HDP – EMC Areas Review

Hematite Decommissioning Project

EMC Investigation Area within LSA 10-04

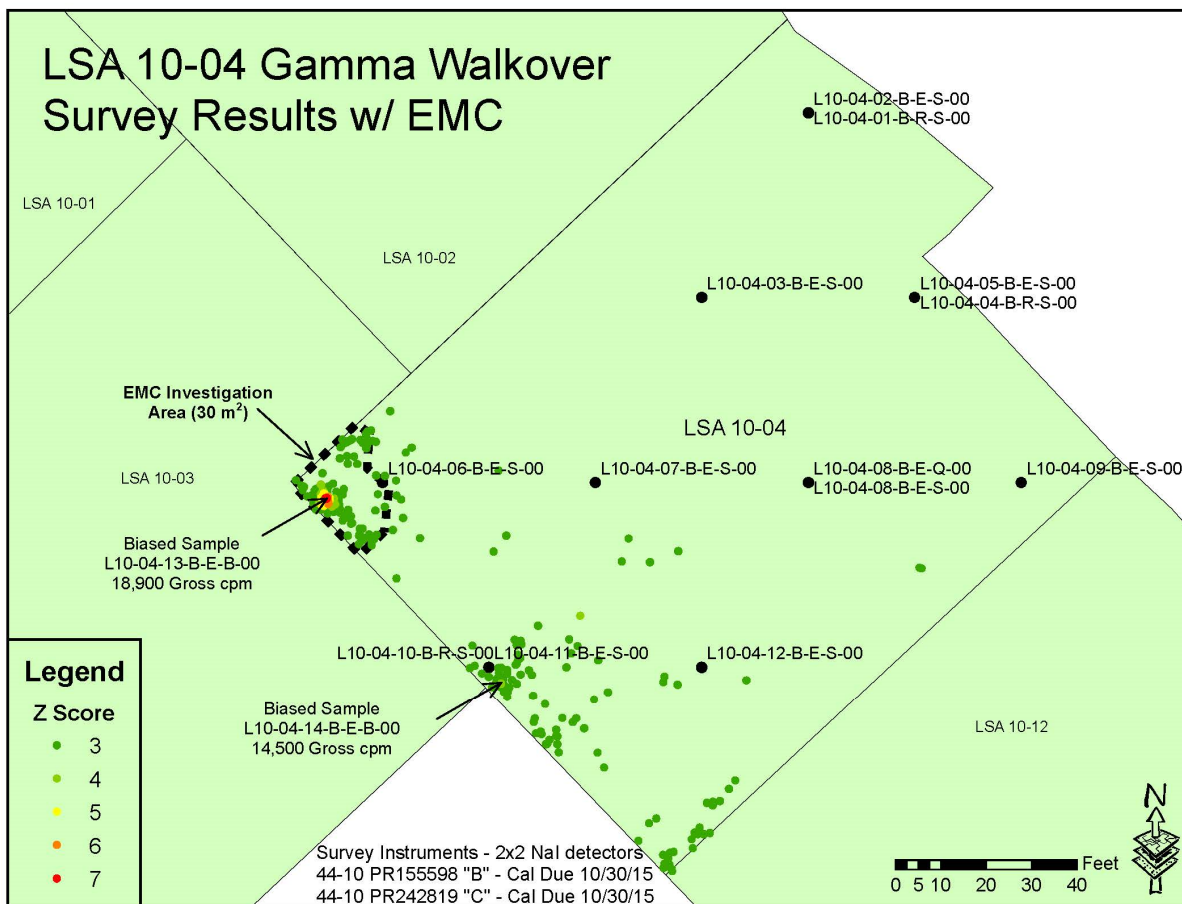
When Uranium is the elevated nuclide, in addition to soil sample data scanning can provide a clear delineation of the size and appropriate boundary of the elevated area. Therefore, whenever possible scanning is used to assist in the determination of the boundary of the elevated area along with soil sample data. As can be seen by the LSA 10-04 figure below, scanning can provide a relatively defined elevated area boundary.

The size of the associated elevated area surrounding this biased location was determined by using the nearest “clean” systematic location and the boundary edges of the SU itself to define a polygonal area of 30 m² as calculated by GIS software. The shape of the EMC area was designed so as to include the elevated GWS measurements proximal to the elevated biased sample.

EMC Investigation Area within LSA 10-07

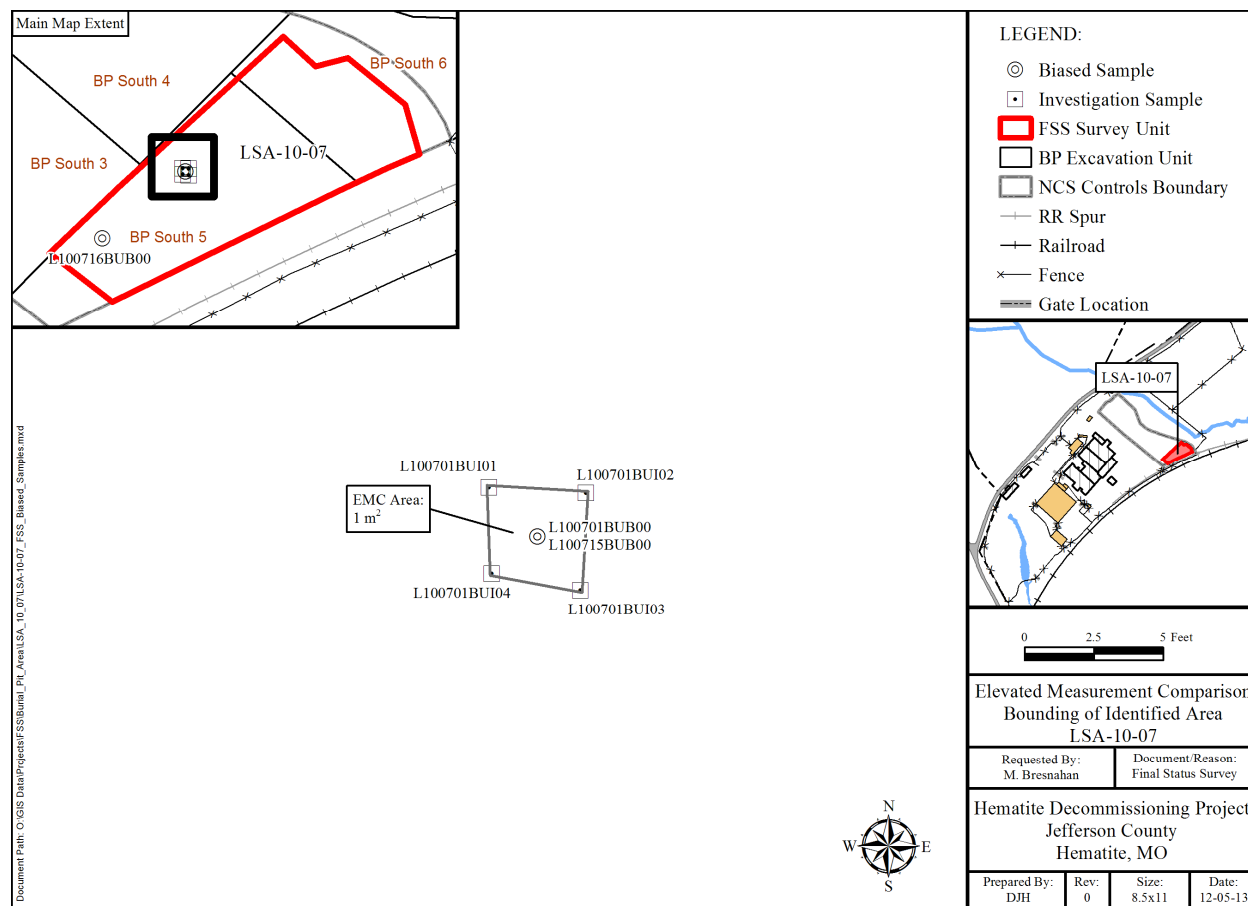
The size of the associated elevated area surrounding this biased location was determined by “bounding” where four investigation samples were collected in a 1 meter square grid surrounding the sample. As all four investigation samples had SOF results less than 1.0, the area was determined not to exceed 1 m². Furthermore, subsequent scanning of the area indicated that the count rates had greatly decreased since the first biased sample was collected. An additional sample (L10-07-15-B-U-B-00) was collected at the exact sample location as the elevated sample, but at a depth of 6 to 12 inches bgs, (where the original sample was collected at 0 to 6 inches bgs). This sample also had a result that was less than a Uniform SOF of 1.0. These sample results indicate a very small area of elevated contamination that was contained within the elevated biased sample (e.g. deconning by sampling), and was no longer present in the SU. Nevertheless, an EMC was performed to demonstrate that the results of the elevated biased sample still meet the release criteria within the LSA.
